FROM **Shinji Coram**  
TOTAL PAGES 13**R-B4711.059**  
**Quintet**  
**Roof Replacement**

REGARDING **Quintet Clubhouse Roof Replacement**

As requested by Kin Living, on behalf of the Quintet Condominiums Association, RDH performed review of the Quintet Condominiums Clubhouse building, to verify the findings presented in a Roof Condition Assessment Report authored by PONO Building Consultants (PONO). RDH has performed various assessments for the Quintet Condominiums in the past, including most recently a Building Enclosure Condition Assessment (BECA) in March 2022.

Figure 6

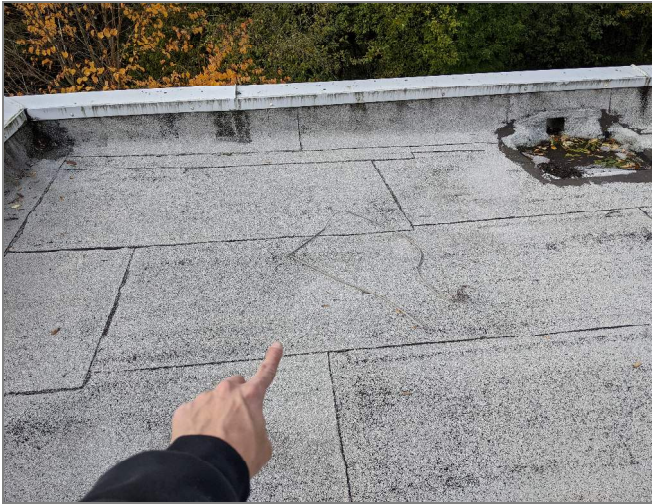
Additionally, at the pool hall roof, the roof deck appears to be bowing slightly in between structural beams. There is some apparent flex in the roofing at cricket valleys.

Apparent bowing or crowning of pool hall roof between glulam beams.

Figure 17

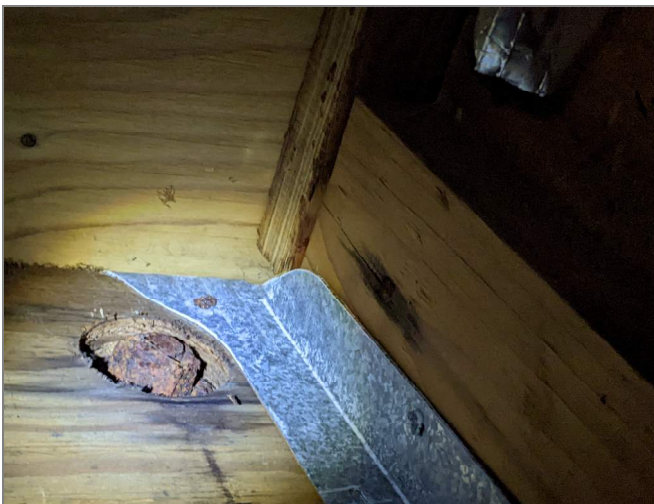
Wood components generally appear to be in sound condition, with the exception of the leak damaged area. Surface corrosion on metallic elements such as bolts indicate a history of high moisture in the environment. Foam is packed between the CMU and the Glulam beams, but is not fully sealed and allows for high moisture air from the pool room to enter the crawlspace.

*TJI's and plywood deck appear in sound condition, corrosion on structural bolts.*
